UNITED STATES PATENT AND TRADEMARK OFFICE

APPLICATION NO.	FILING DATE	FIRST NAMED INVENTOR	ATTORNEY DOCKET NO.	CONFIRMATION NO.
10/820,905	04/08/2004	Brandon Mouw	12528.005	8851

Office Action Summary	Application No. 10/820,905	Applicant(s) MOUW, BRANDON	
	Examiner Philip Gabler	Art Unit 3637

DETAILED ACTION

Weber '662 Figures 1 and 3

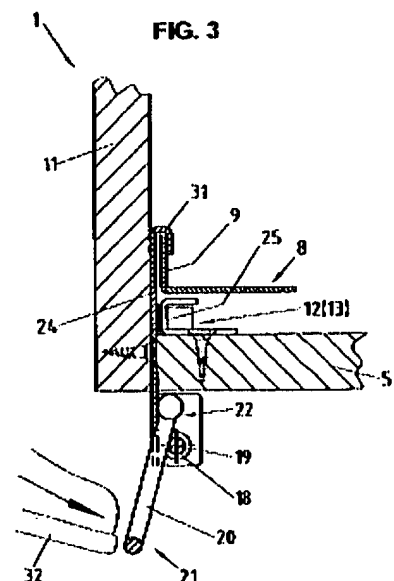
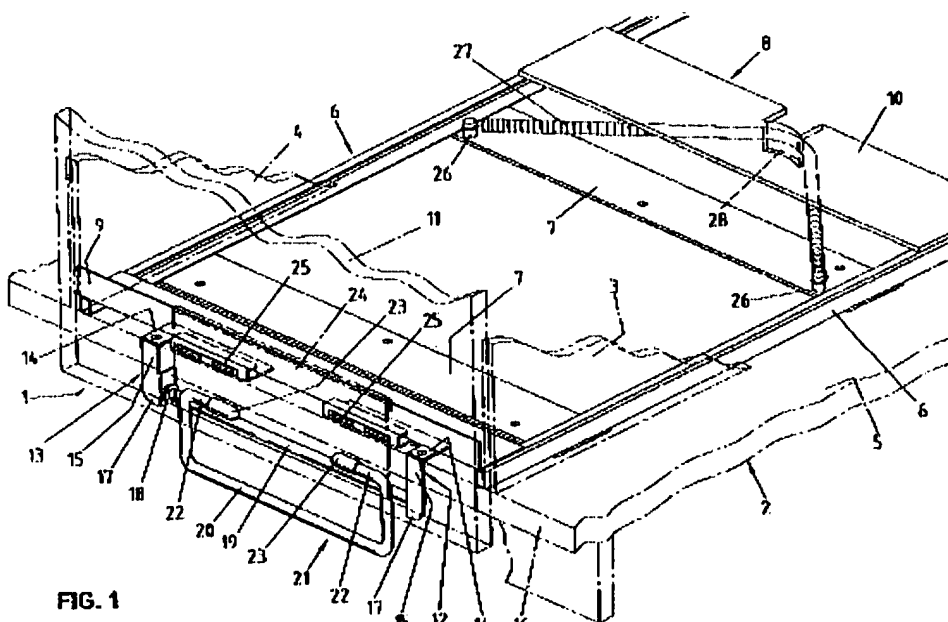
11. Claims 1, 3, 4, 7, 8, 12, 13, 15-17, 20, 22, 24, 30, 33, and 35 are rejected under 35 U.S.C. 102(b) as being anticipated by Weber (US Patent Number 5975662). Weber (Figures 1 and 3) discloses a drawer capable of being used as a waste bin manager having a door (11) and comprising: a first elongated slide (6) adapted to be mounted within the cabinet; a second elongated slide (also 6, on opposite side) adapted to be mounted within the cabinet, said second elongated slide being space apart from, and oriented generally parallel to, said first elongated slide; a "wire" harness (10) positioned between, and attached to, said first and second elongated slides [it is viewed that the recitation of a "wire harness" is not given specific structural characteristics since the

limitation has not been further defined within the claim and is therefore given a broad interpretation], said wire harness capable of holding a waste bin; a clip (28) attached to said wire harness; and a spring (27) having a first (rear) end attached to said clip and a second (front) end attached to the cabinet (at point 26), said spring adapted to pull against said wire harness such that the first and second elongated slides, as well as the wire harness and door, are pulled at least partially out of the cabinet when the cabinet is opened.

12. Regarding claim 3, while not discussed by Weber, it is inherent from the shape of the clip that the spring is in one orientation to be inserted into/engaged with said clip and moved to a second orientation to couple said spring to said clip.

13. Regarding claim 4, the position is taken that the clip could be capable of attaching to a first and second wire if such were present due to the clip's curved body, as best understood (note the 112, 2nd paragraph rejection above).

14. Regarding claim 7, Weber further discloses a foot-operated mechanism (21, 24, 25) adapted to release the door from the cabinet.

15. Regarding claim 8, Weber further discloses the foot-operated mechanism includes a lever (21), a plate (24), and a magnet (25), one of said plate and said magnet being attached to the door and the other of said plate and magnet being attached to the cabinet, said lever positioned to cause separation between said plate and said magnet when said lever is rotated.

16. Regarding claim 12, Weber further discloses that the second end of the spring is attached to a wall of the cabinet (via members 6 and 7).

17. Regarding claim 13, Weber further discloses said spring is oriented substantially completely in a horizontal plane (see Figure 1).

18. Regarding claim 15, Weber further discloses said spring extends substantially the entire distance across the space between the first and second slides (see Figure 1).

19. Regarding claim 16, as best understood, Weber further discloses said clip is positioned underneath said wire harness (and would therefore be positioned under a waste bin held by said harness).

20. Regarding claim 17, Weber further discloses the first and second slides are attached to the door (via frame 8 and drawer 1). See column 3 lines 16-23.

21. Regarding claim 20, Weber discloses a drawer capable of being used as a waste bin manager having a door (11) and comprising: a slide mechanism (6 and associated components) adapted to move between a retracted position within the cabinet and an extended position at least partially outside of the cabinet (note that Weber's figures show stationary guides, 6, but not the associated drawer mounted guides, which are disclosed in column 3 lines 16-18); a waste bin holder (10) supported by said slide mechanism, said waste bin holder capable of holding a waste bin; a clip (28) at said waste bin holder; and a spring (27) having first (rear) end attached to said clip and a second (front) end attached to the cabinet, said spring adapted to exert a force against said waste bin holder such that the slide mechanism is moved at least partially out of the cabinet when the cabinet is opened.

22. Regarding claim 22, as best understood, Weber further discloses said clip is positioned underneath said waste bin holder (and would therefore be positioned under a waste bin held by said holder).

23. Regarding claim 24, Weber further discloses said slide mechanism is mounted at or near a bottom wall (5) of said cabinet (see Figure 1).

24. Regarding claim 30, Weber further discloses said clip (28) is attached to said waste bin holder (10).

25. Regarding claim 33, Weber further discloses the waste bin holder (10) comprises a wire harness.

26. Regarding claim 35, Weber further discloses said second end of spring is attached to a wall of said cabinet (via members 6 and 7).

Brilando et al. '549 Figures 1 and 3

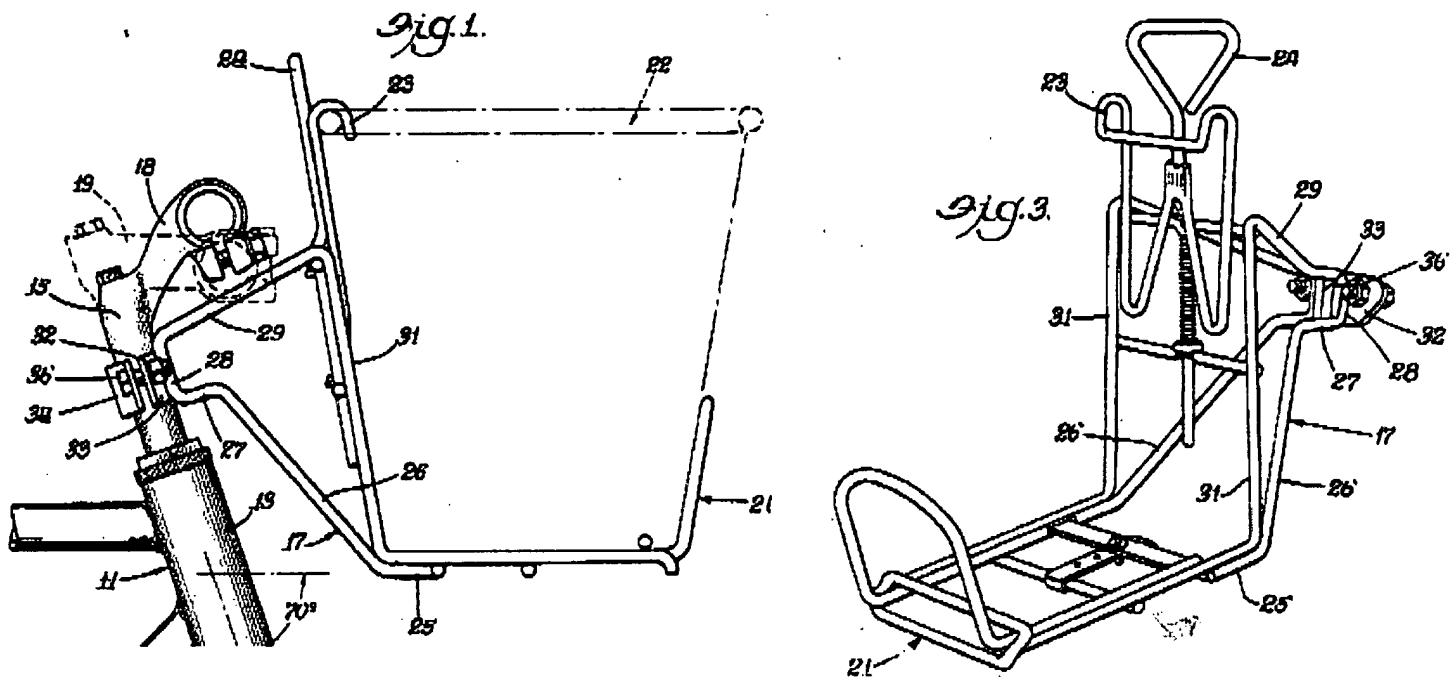
28. Claim 2 is rejected under 35 U.S.C. 103(a) as being unpatentable over Weber in view of Brilando et al. (US Patent Number 3603549). Weber discloses a drawer/waste bin manager as recited in claim 1 but does not disclose a wire harness adapted to exert a biasing force against a waste bin. Brilando (Figures 1 and 3) discloses a bin holder (21) capable of exerting a biasing force (through member 23) against a bin (22) held by the holder. Accordingly, it would have been obvious to one of ordinary skill in the art at the time the invention was made to modify Weber's wire harness/waste bin holder to include a structure capable of exerting a biasing force against a waste bin as taught by Brilando because this arrangement would provide more stability (prevent overturning, etc.) to waste bins held in Weber's manager.

Exhibit 1: Reed '185 Figures 3 and 7

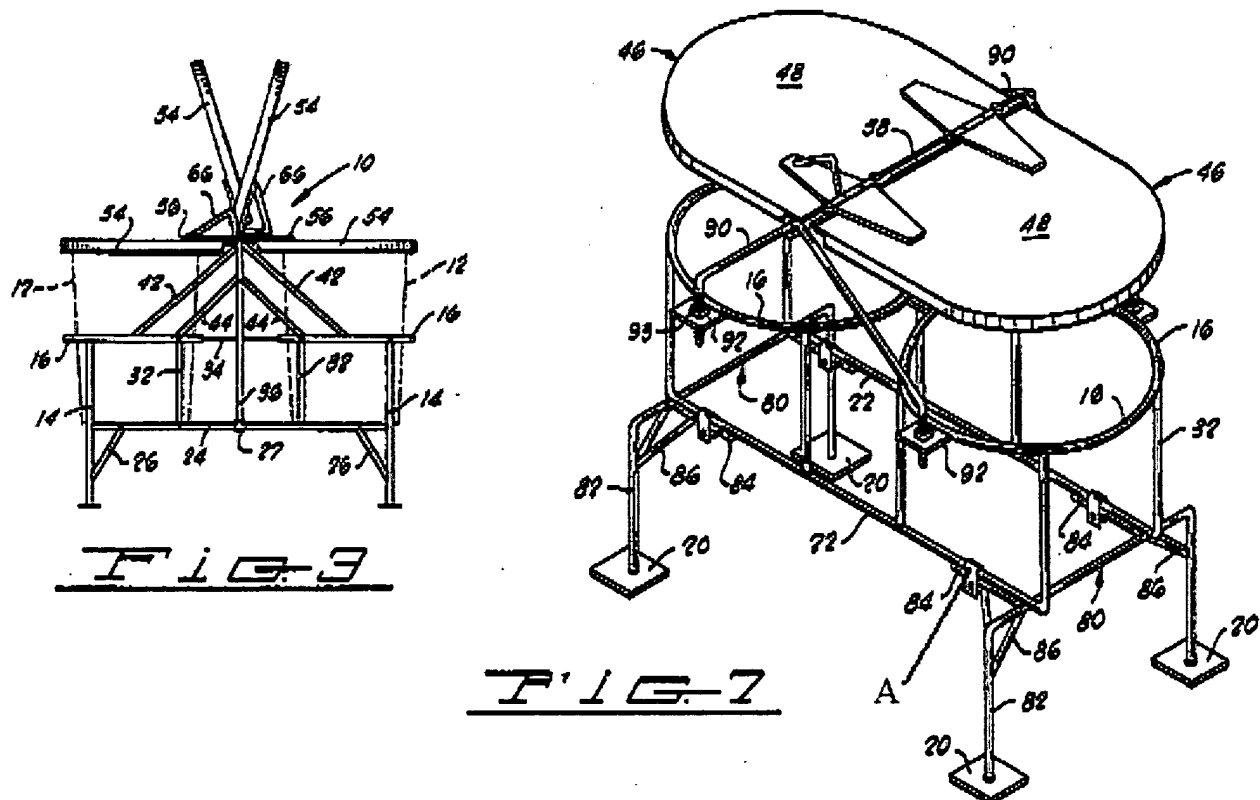
29. Claims 14, 31, 32, 34 are rejected under 35 U.S.C. 103(a) as being unpatentable over Weber in view of Reed (US Patent Number 3167185). Weber discloses a drawer/waste bin manager as recited in claims 1 and 30 but does not disclose a clip attached to the harness adjacent the first elongated slide. Reed (Figures 3 and 7) discloses a waste bin manager (10) comprising a wire harness/waste bin holder (16, 32, etc. but neglecting leg structure 80) including a clip (viewed as A in Exhibit 1) on the periphery of his harness. Accordingly, it would have been obvious to one of ordinary skill in the art at the time the invention was made to modify Weber's wire harness/waste bin holder to include a more thorough structure as taught by Reed (and suggested by Weber in column 1 lines 10-13) because this arrangement would provide more stability

to waste bins held in Weber's manager as well as simplifying his spring mounting arrangement by placing a clip for mounting the spring adjacent the first elongated slide.

30. Regarding claim 31, Reed further discloses the clip is releasably attached to said waste bin holder.

31. Regarding claim 32, Reed further discloses said wire harness/waste bin holder has an open upper end (encircled by 16) capable of receiving a waste bin and a lower end (22, 24), said clip being attached to said lower end of said wire harness/waste bin holder.

32. Regarding claim 34, Reed further discloses said waste bin holder comprises a pair of wire harnesses (two rings 16, as well as associated components for both).

Exhibit 2: Remmers '860 Figure 7

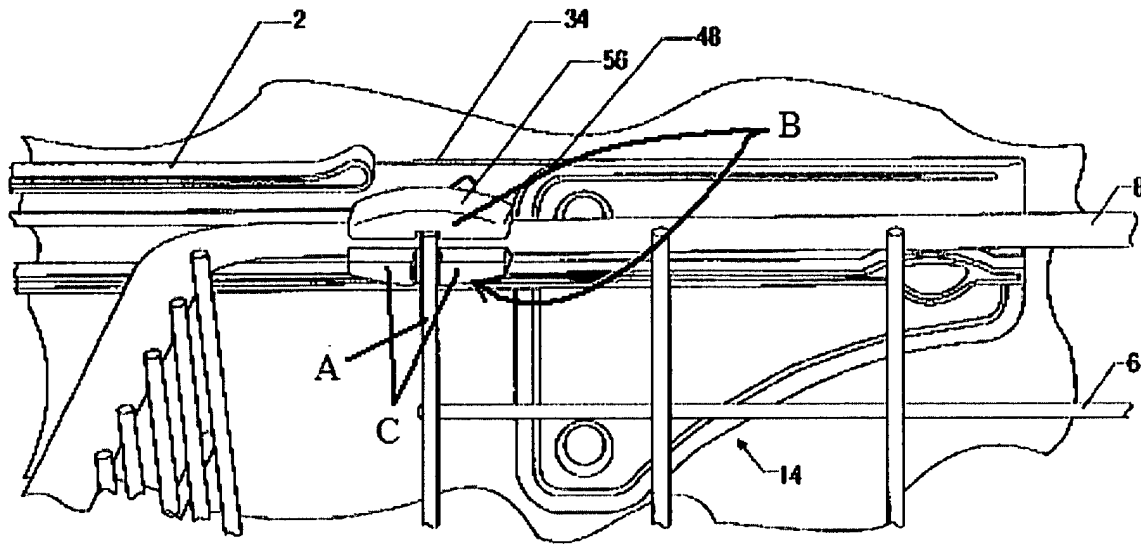
33. Claims 4-6 and 21, as best understood, are rejected under 35 U.S.C. 103(a) as being unpatentable over Weber in view Remmers (US Patent Number 6467860).

Weber discloses a drawer/waste bin manager as recited in claims 1 and 20 but does not disclose a first and second wire. Remmers (Figure 7) discloses a wire drawer (6) having a first wire (8) and a second wire (viewed as A in Exhibit 2), as well as a clip (56) attached to the first and second wires at their intersection. Accordingly, it would have been obvious to one of ordinary skill in the art at the time the invention was made to modify Weber's wire harness to a more substantial structure including first and second wires as taught by Remmers because this arrangement would allow for more stability for waste bins placed in Weber's harness (via a more thorough harness structure).

34. Regarding claim 5, Remmers further discloses said first and second wires intersect each other at a right angle.

35. Regarding claim 6, Remmers further discloses said clip includes a first set of arms (B) adapted to wrap at least partially around a first wire in said wire harness and a second set of arms (C) that are adapted to wrap at least partially around a second wire in said wire harness.

36. Regarding claim 21, Remmers further discloses said clip is made of plastic (column 5 lines 4-5) and is adapted to releasably grip a wire on said waste bin holder (see Figure 7).

Parker '197 Figures 1 and 2

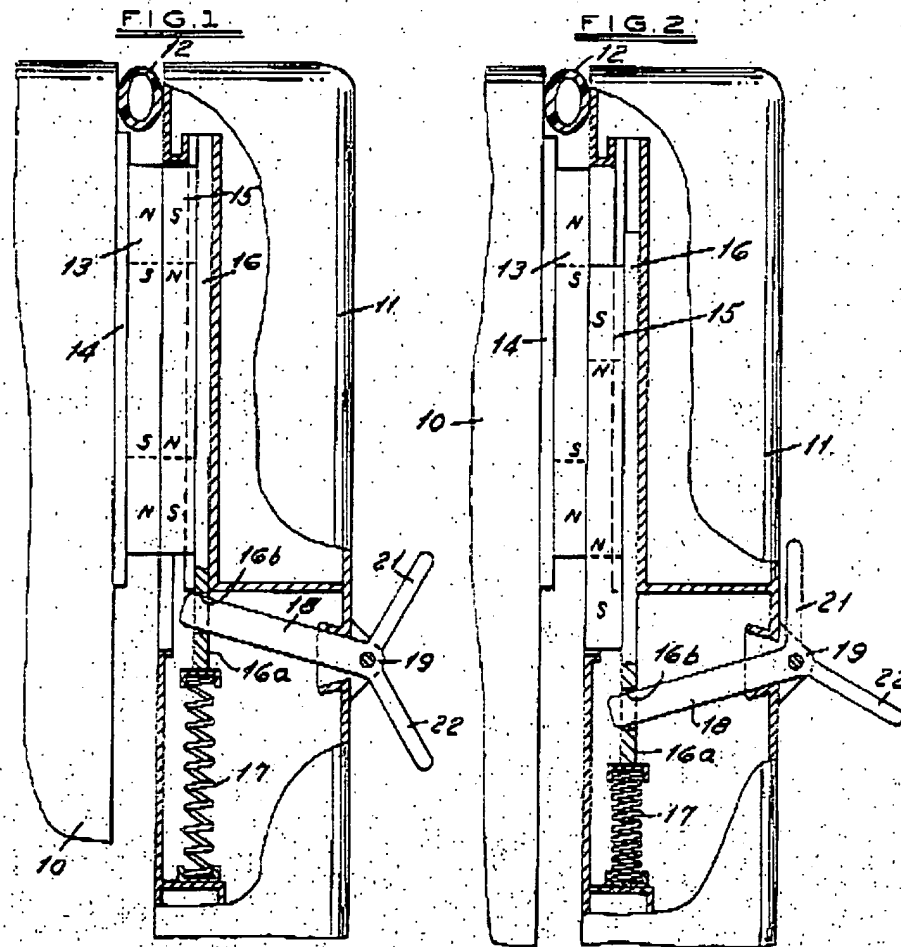
37. Claims 9 and 10 are rejected under 35 U.S.C. 103(a) as being unpatentable over Weber in view of Parker (US Patent Number 3790197). Weber discloses a drawer/waste bin manager as recited in claim 8 but does not disclose the magnet attached to the lever. Parker (Figures 1 and 2) discloses a latching mechanism including a magnet (15) attached (via component 16) to a lever (18, 21). Accordingly, it would have been obvious to one of ordinary skill in the art to modify Weber's mechanism to include a magnet attached to the lever as taught by Parker because this arrangement would allow more control of the opening force required.

38. Regarding claim 10, Parker further discloses a lever with a generally flat bottom surface (22) that a user may push upward against in order to cause the lever to

separate the latching mechanism (note in Figures 1 and 2 that the opening motion requires an upward movement of member 22).

Difley et al. '875 Figures 1-3

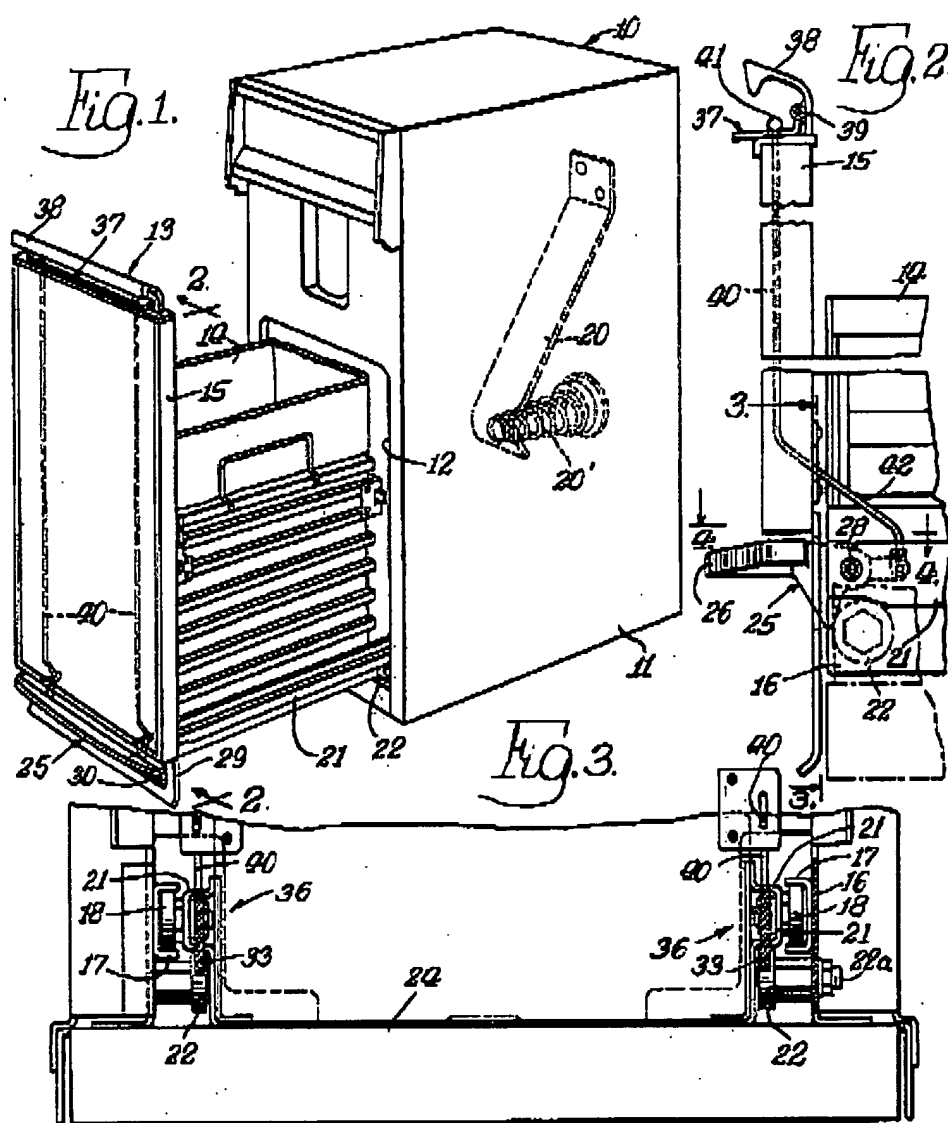
39. Claims 11, 18, 19, 23, 25-29, and 36 are rejected under 35 U.S.C. 103(a) as being unpatentable over Weber in view of Difley et al. (US Patent Number 4023875). Weber discloses a waste bin manager as recited in claims 1, 17, and 20 but does not disclose telescoping slides. Difley (Figures 1-3) discloses a drawer mounted waste

compactor with telescoping slides (17, 21). Accordingly, it would have been obvious to one of ordinary skill in the art at the time the invention was made to modify Weber's manager to include telescoping slides as taught by Difley because this arrangement would provide a readily available yet strong means for drawer operation.

40. Regarding claims 18 and 36, as best understood, Difley further discloses the door (15) is attached only to the slides/extensible members (see Figure 2).

41. Regarding claim 19, Difley further discloses the slides are positioned underneath a waste bin (14) positioned within the enclosure (10).

42. Regarding claim 23, Difley further discloses said slide mechanism includes a pair of slides (on opposite sides of the compactor), each slide including a stationary member (17) mounted to a cabinet and an extendable member (21) mounted to a door.
